Technical change to 3- and 4-pole unshielded M8 cord sets

The 3- and 4-pole unshielded M8 cord sets will be lead-free in accordance with ROHS requirements, without the exception 6c. The changeover to the new design is carried out on the article number.

Old design	New design
M8 socket straight

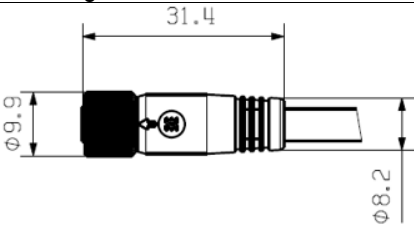
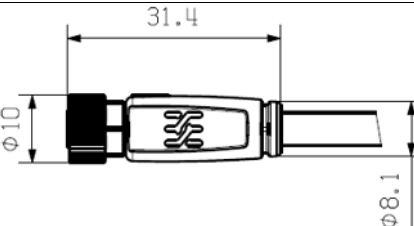
Until now, lead-containing materials were used for some components of the affected articles. As part of the changeover, these will be converted to lead-free materials so that the products in the new design comply with the RoHS Directive without the exception 6c. The new design will change the Dimensions slightly. See the Table Below for Details.
